REV P2 - ADDITION OF APPENDIX C

H4026-BOW-A1-XX-RP-A-0004_ RESPONSE TO HISTORIC ENGLAND COMMENTS P1

THE GEORGE HOTEL

2.1 Initial Elevation Changes

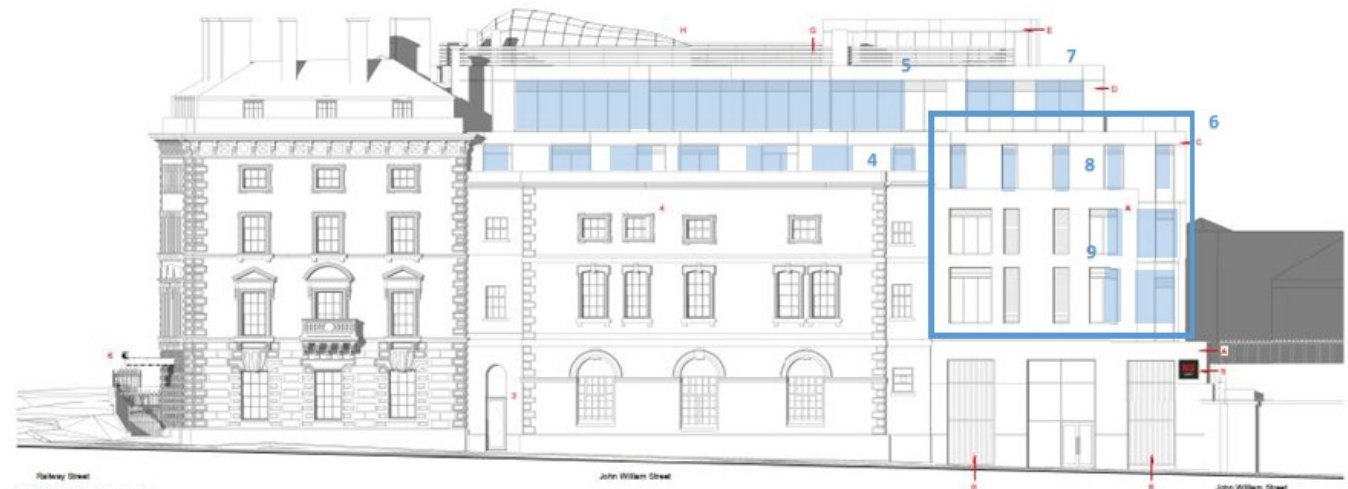
3.0 Initial Design Changes

4.1 Final Elevation Changes

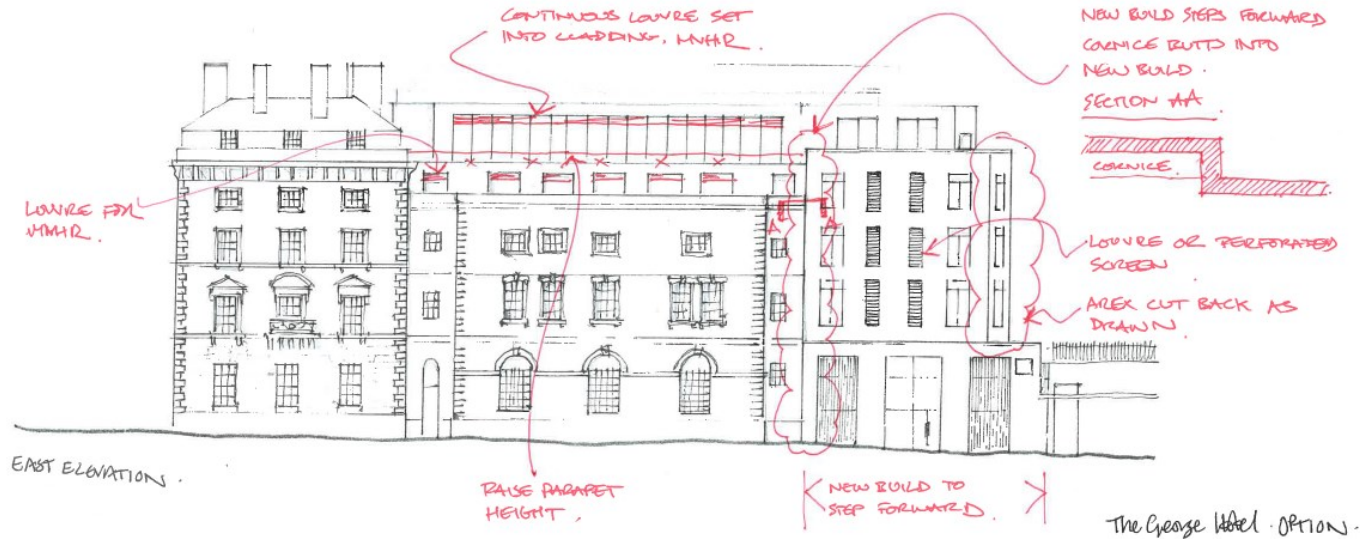
The George Hotel Sketch 22/03/23.

Unusual arrangement of structure at basement

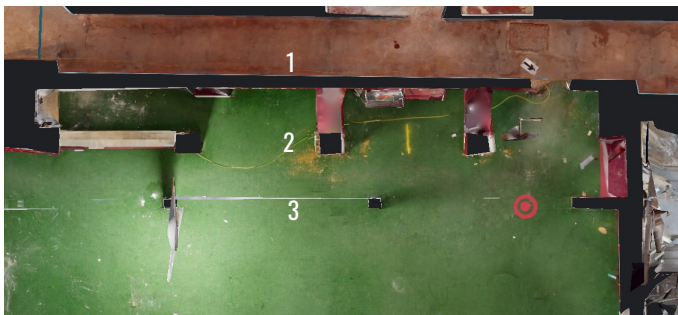
At basement level there appear to be 3 levels of support to the ground floor:

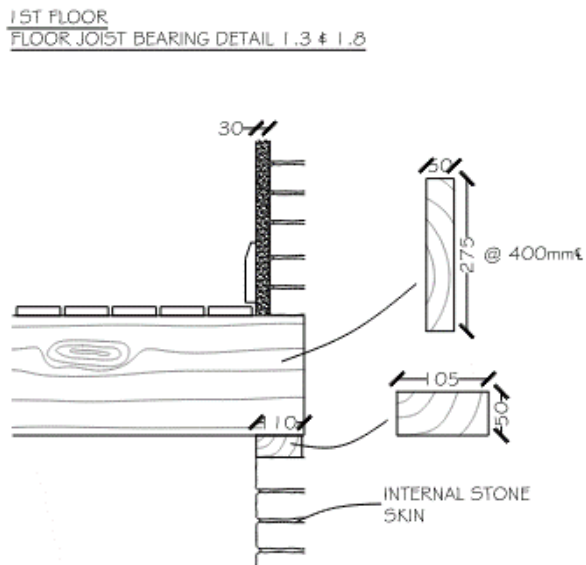
Each of these beams is approximately 1.3m high by 0.5m wide and they are located on the line of the proposed structural frame to Block C (see previous sketch) and the proposed riser locations.

These beams support the floor, wall over and the cornice/downstand detail below.

Reduction in Kitchen size at ground floor

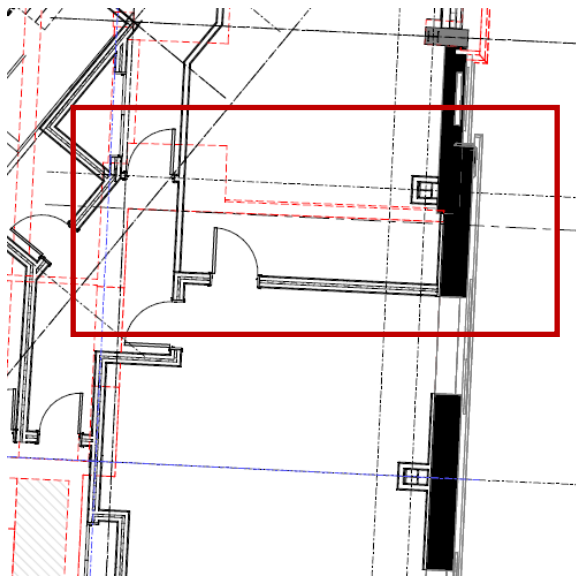
The north wall to the dining room needs to be relocated further into the dining room in order to create the correct kitchen size. If this wall was to be retained it would not be possible to create a functioning kitchen equipped to deal with the number of guests required.

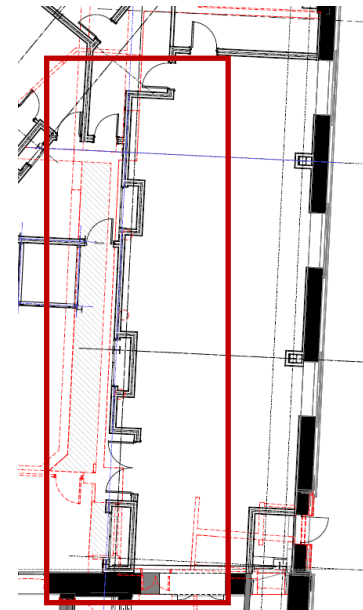
As can be seen from the excerpt of the ground floor drawing below, which shows an overlay of the proposed construction on the demolition which is indicated by a dashed red line, the position of the risers clashes with the location of the large steel beams supporting this wall.

These risers are on the location of the wall separating the balconies from the bedrooms and as such cannot be moved further into the bedrooms as these will result in a reduction of the room size which are already at a minimum.
